**ADDENDUM NO. 3**  
**GEORGETOWN ELEMENTARY SCHOOL**  
**CLASSROOM & KITCHEN ADDITIONS**  
Georgetown, Delaware 19947

May 27, 2015

The documents for the above referenced project, Project Manual, dated March 2, 2015 and Drawings, dated April 10, 2015, and subsequently issued addenda are amended as follows:

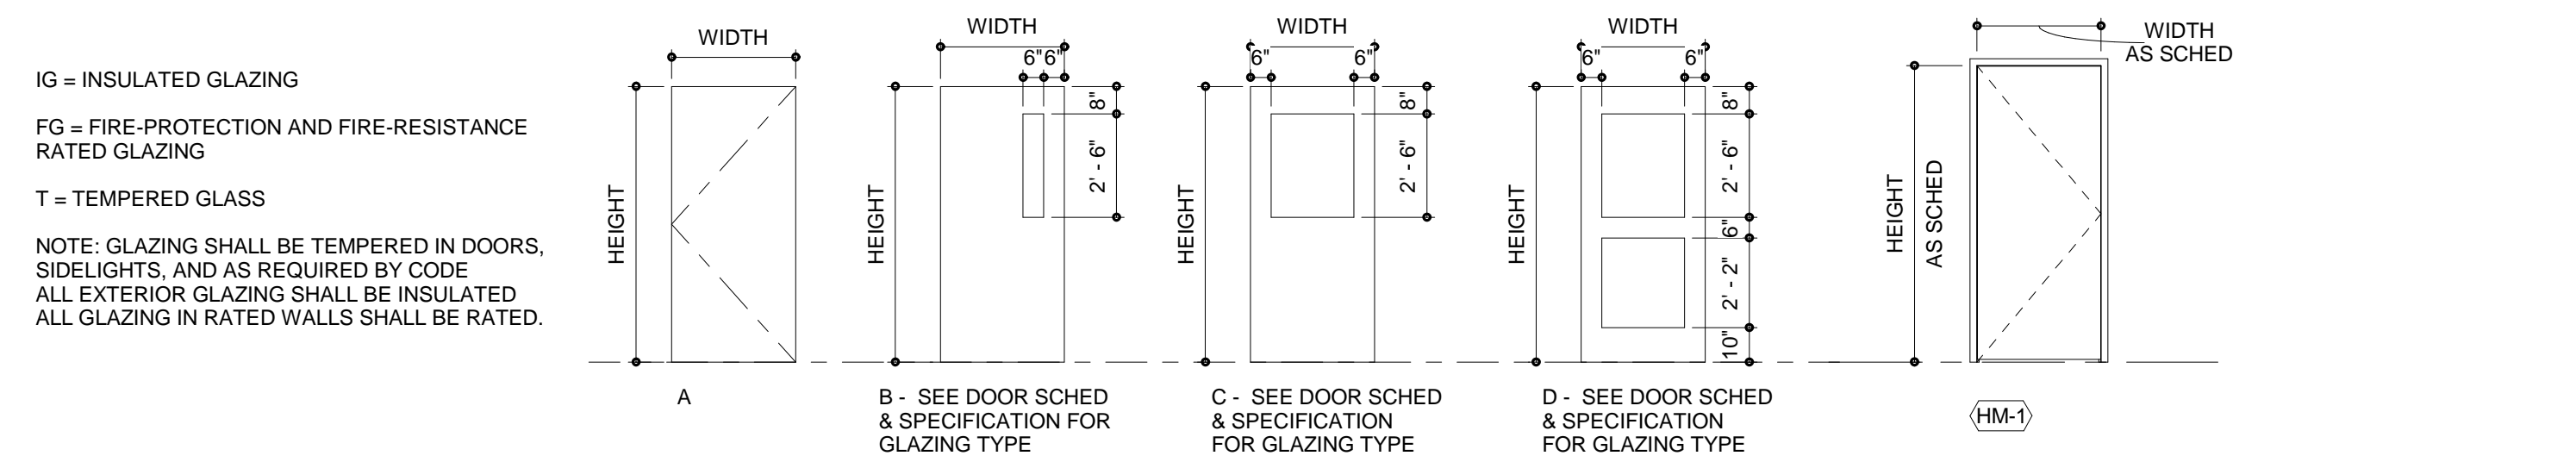
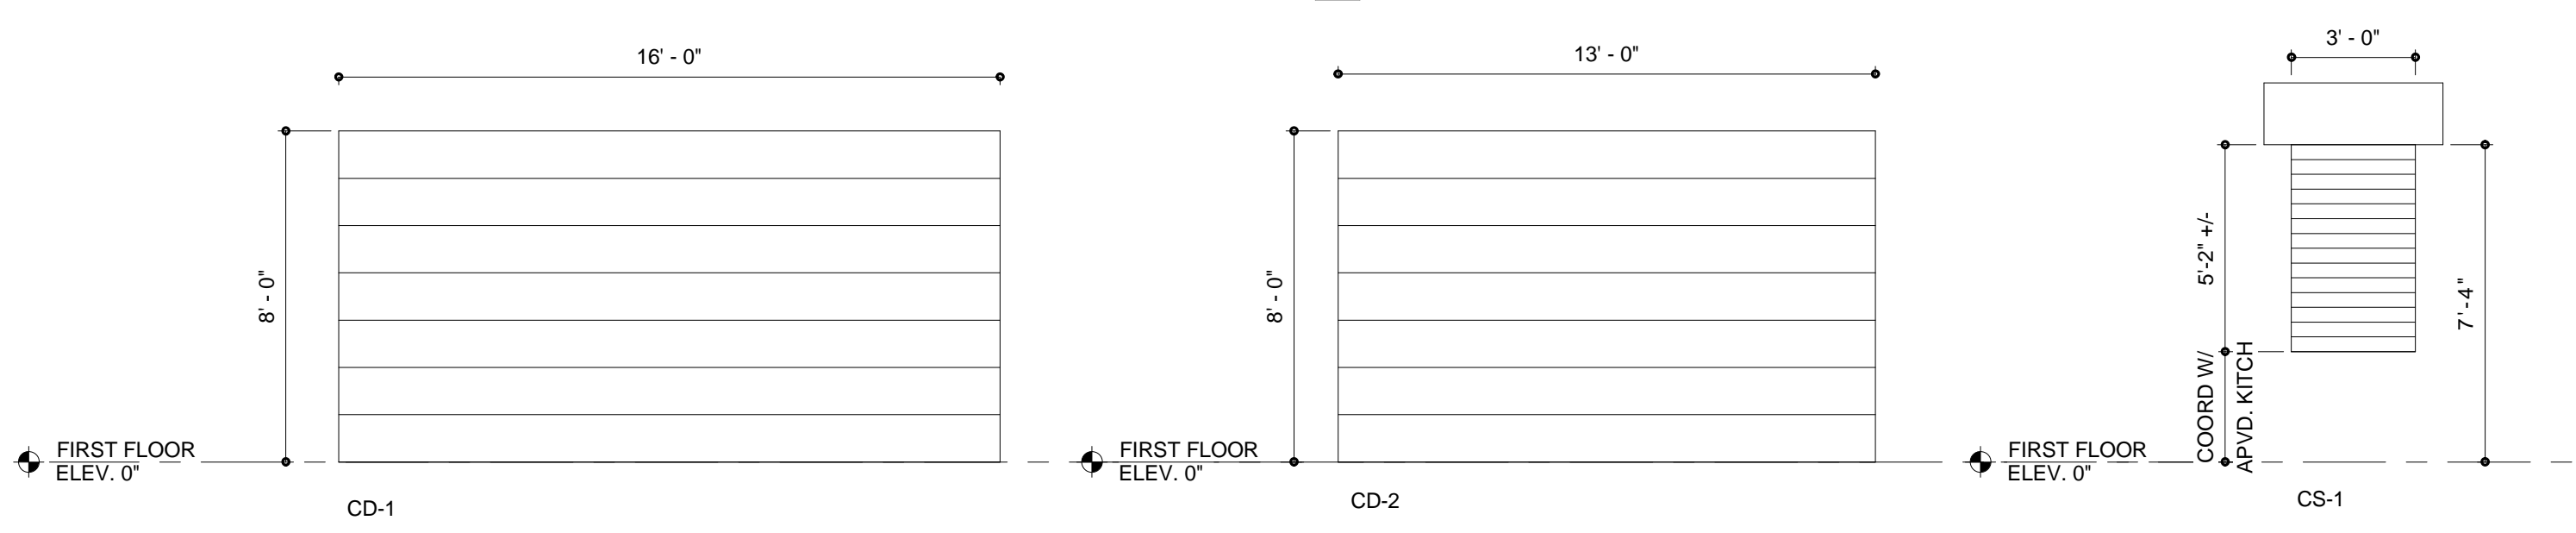
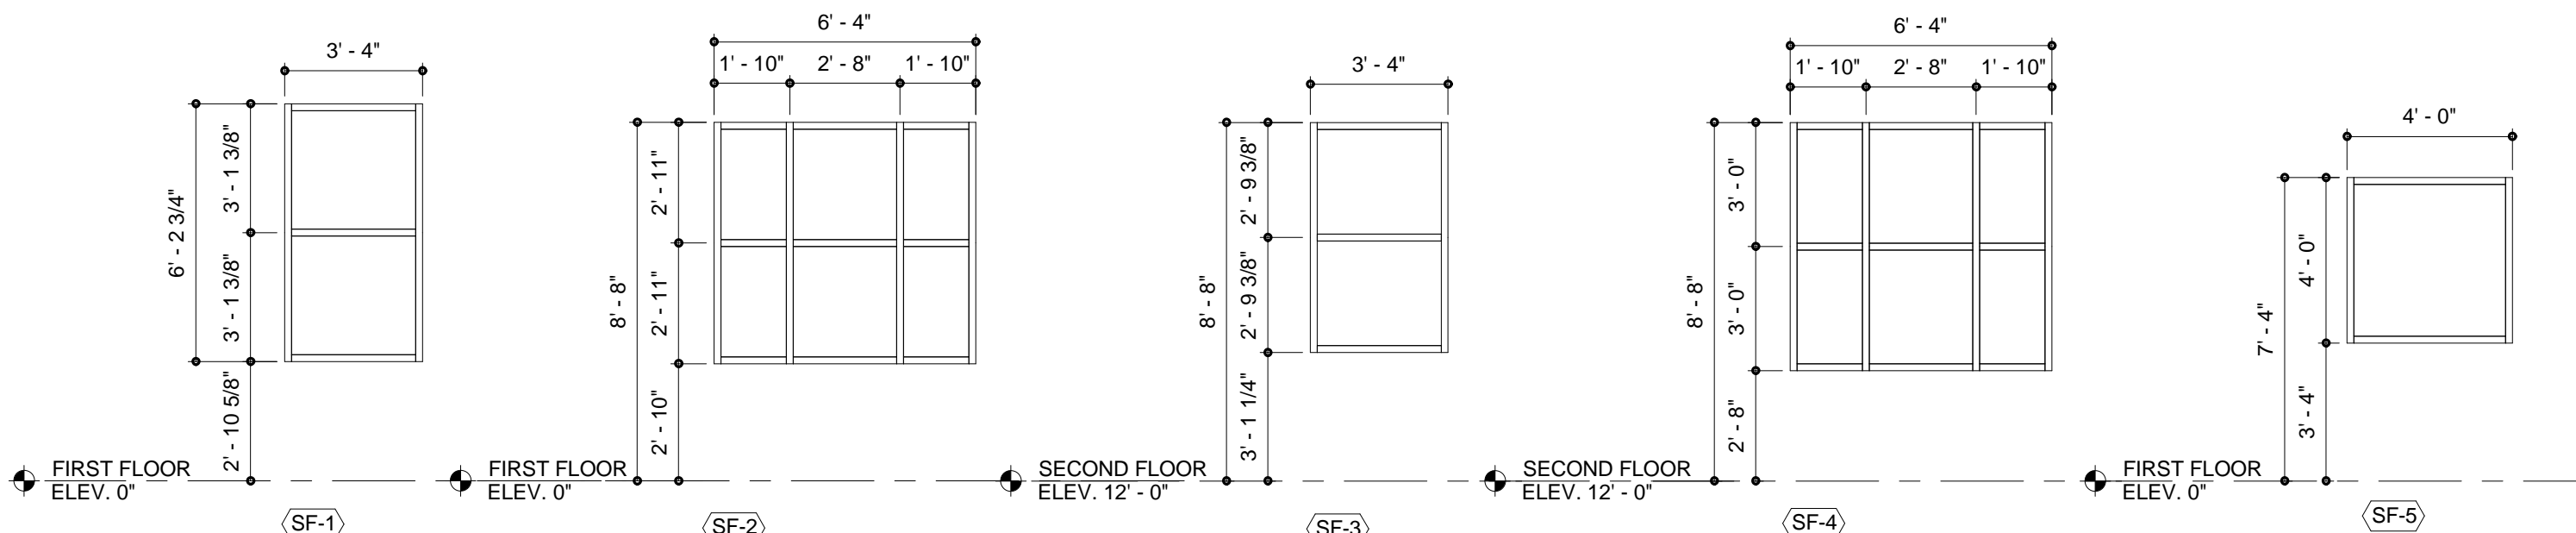
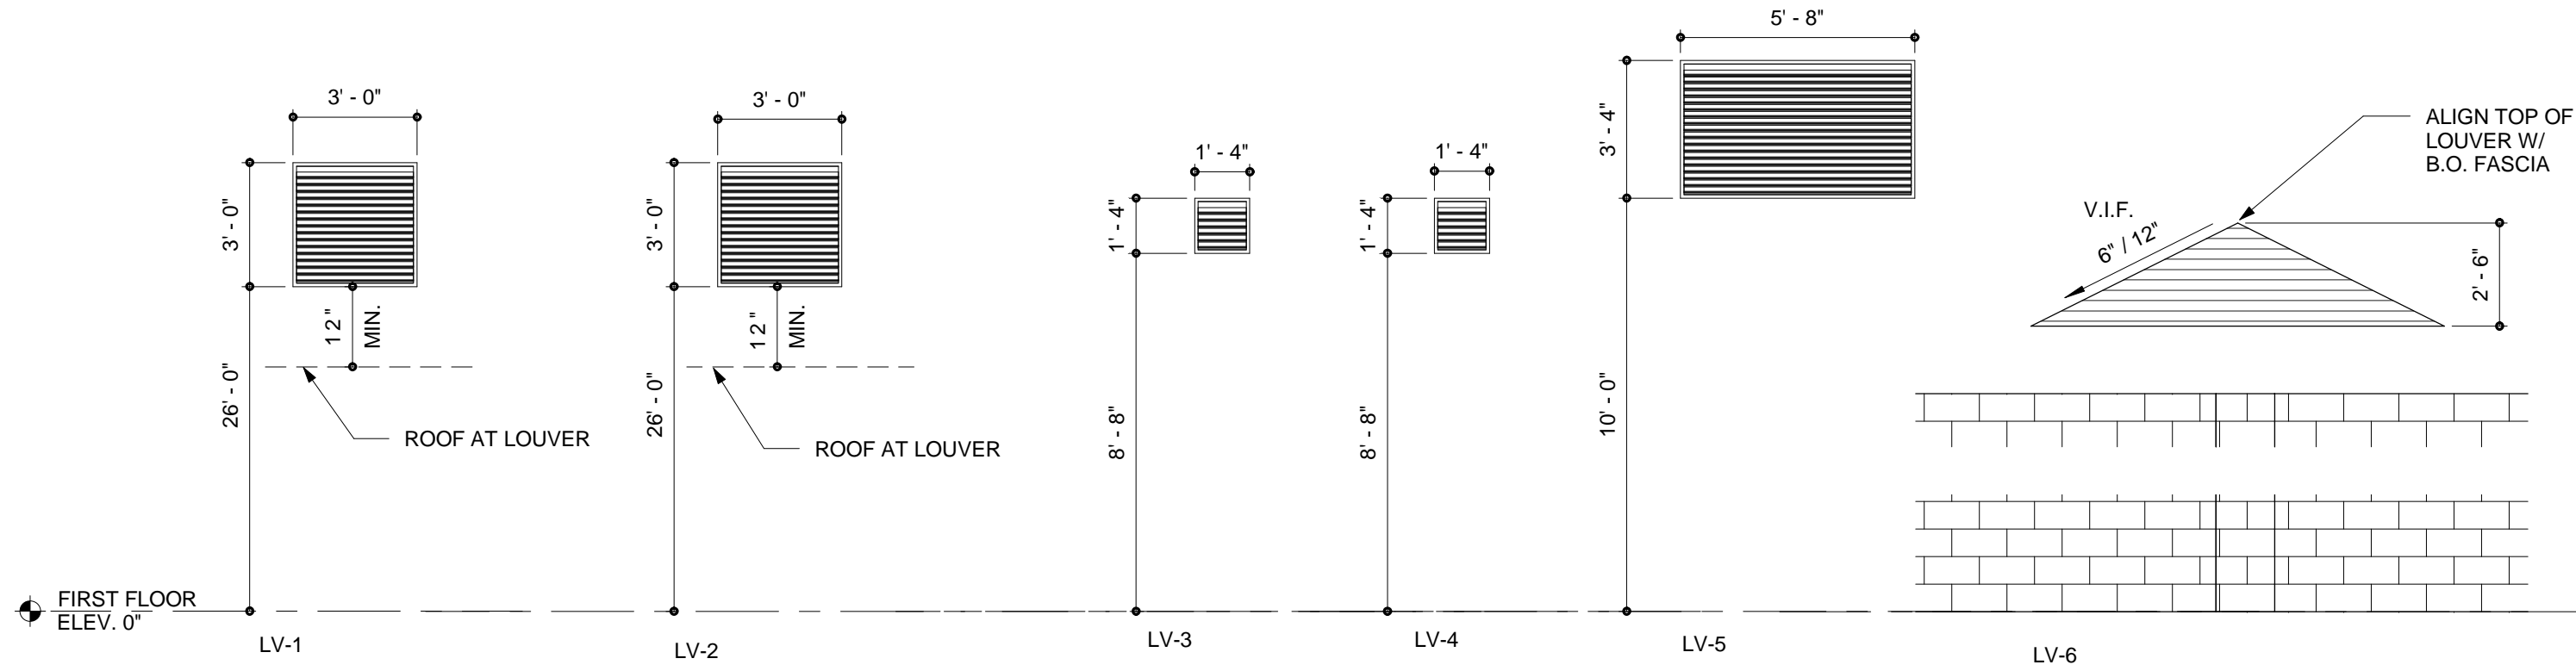
17. A601 Finish Schedule and Legend, Door Schedule, Door and Window Types and Details
  - a. ADD rooms per attached drawing: Vestibule 108, Boys Toilet 231, Storage 232, Mechanical 233, Shower 318A, and Girls Toilet 322C.

- b. Multipurpose Room 132: REVISE comments per attached drawing.
  - c. Equipment Platform 299: REVISE ceiling finish from "PT" to "-".
18. A602 Door and Window Details

DRAWING NUMBER: **PD102**

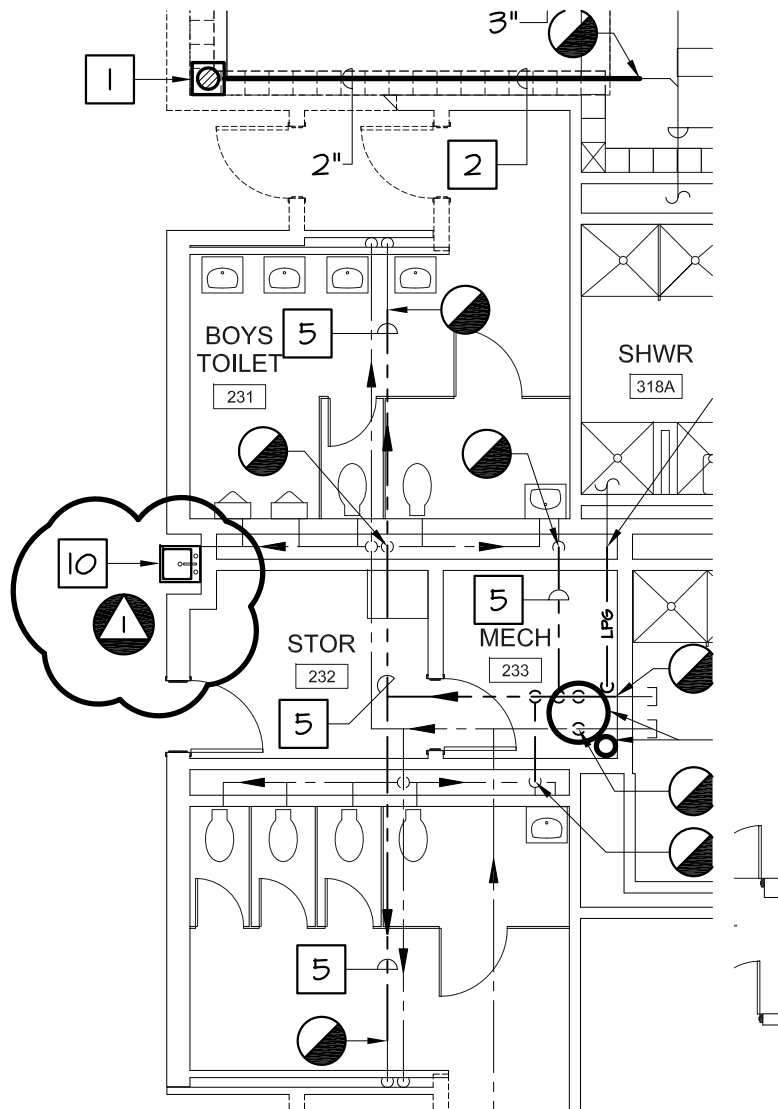
- c. Detail H3: REVISE thru-wall flashing to drop down at lintel.
- 19. PD102 – Plumbing Demolition
  - a. REMOVE existing hand sink per the attached Plumbing Sketch PSK-01.

### KITCHEN ADDITION - LIGHTING - DEMOLITION

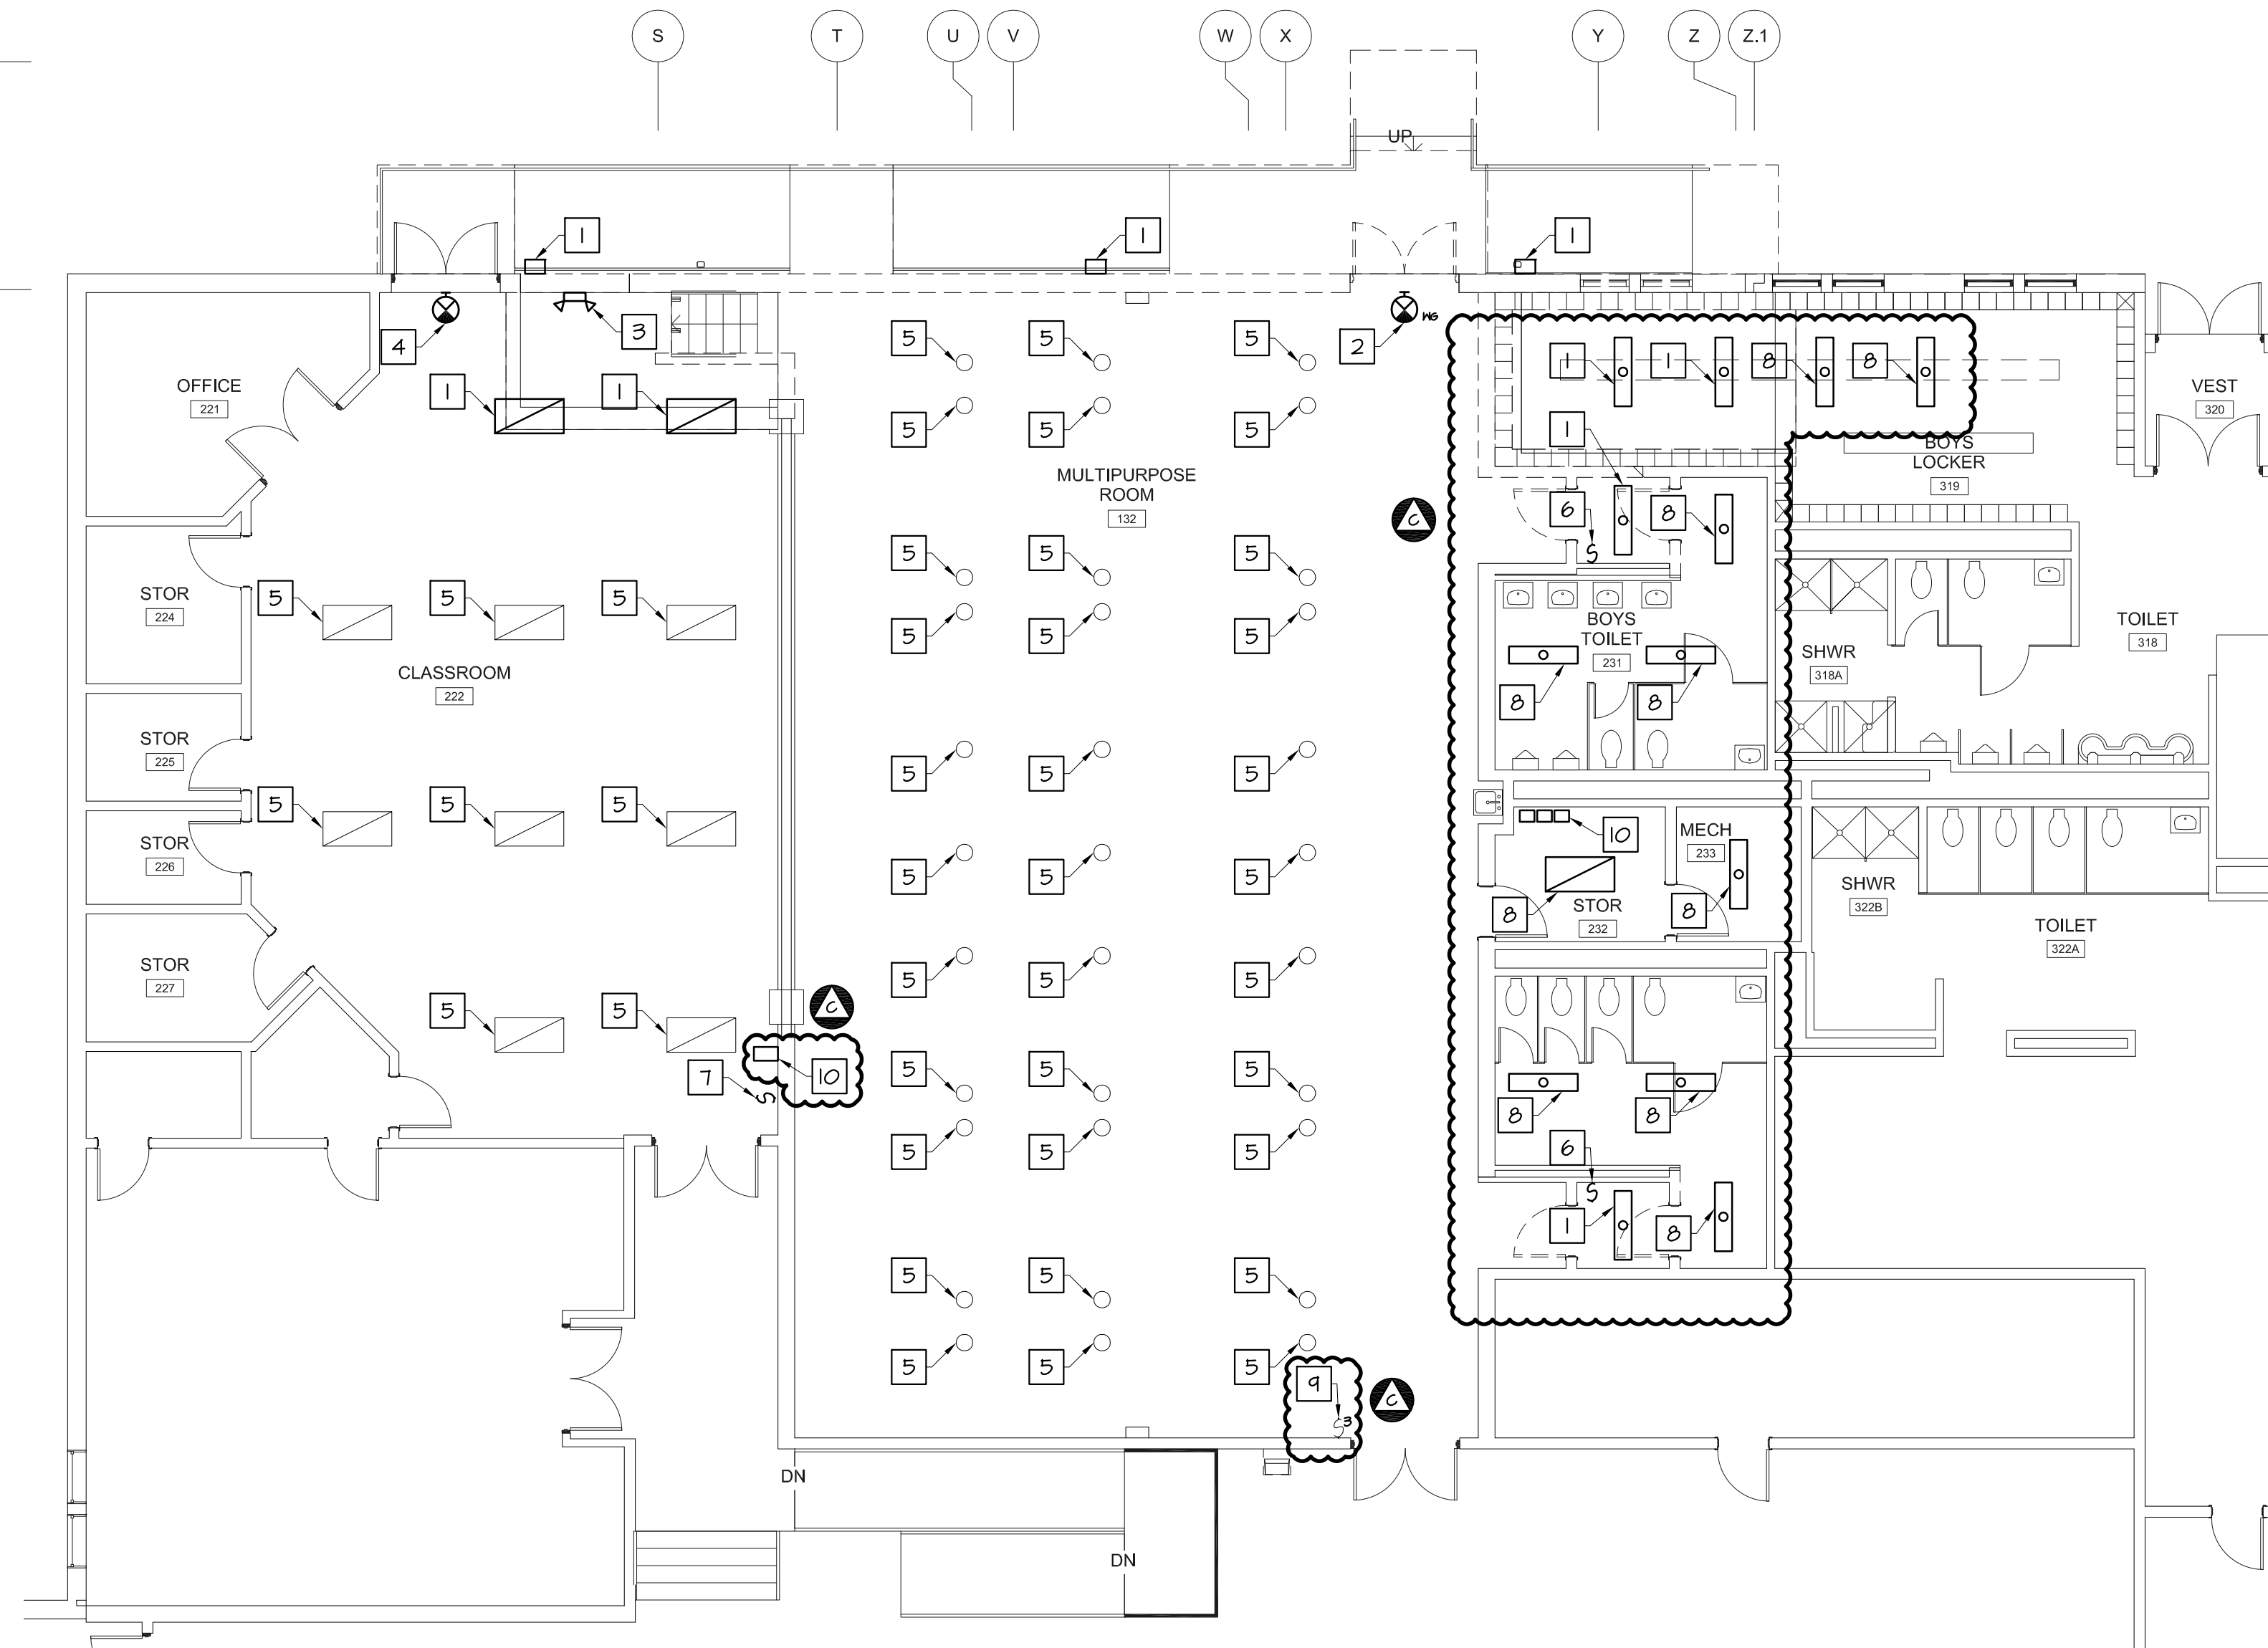
- 22. EDL102 – Kitchen Addition Lighting Demolition:
  - a. REPLACE Drawing EDL102 in its entirety with revised Drawing EDL-102. Changes made to this sheet reflect the demo lighting changes based on the latest architectural plans for the existing toilet room ceilings and alternate 4.
